Announcement of Product Change

PCN No: PCN-2023-26-01

Change Title: Legacy GDM "J" Type

Product Category: Valve

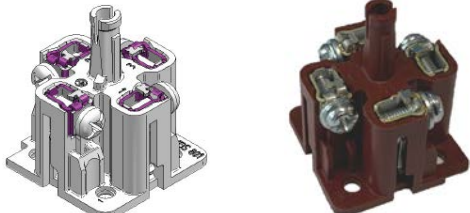
The scope of this change will include updating all bills of materials for affected products and changing from G2 contact barrier to G3 contact barrier. The agency approval documentation will be edited or requalified to reflect the PCN.

Current State	Future State

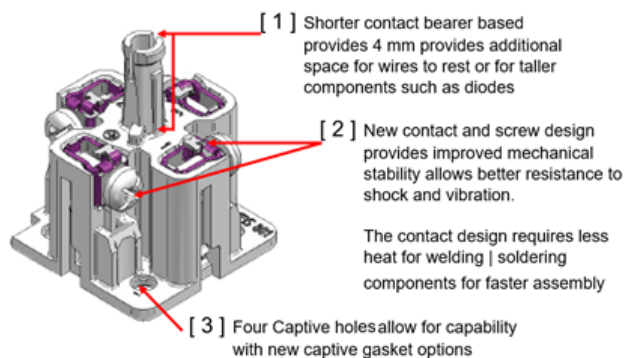
We anticipate little to no impact on customer applications. Customers adding components such as function indication or suppression components will need to consider this change in detail due to the contact design for G3. The contacts design for G3 heats up faster for soldering/welding components. Adjustments to your internal production steps may need to reflect the change.
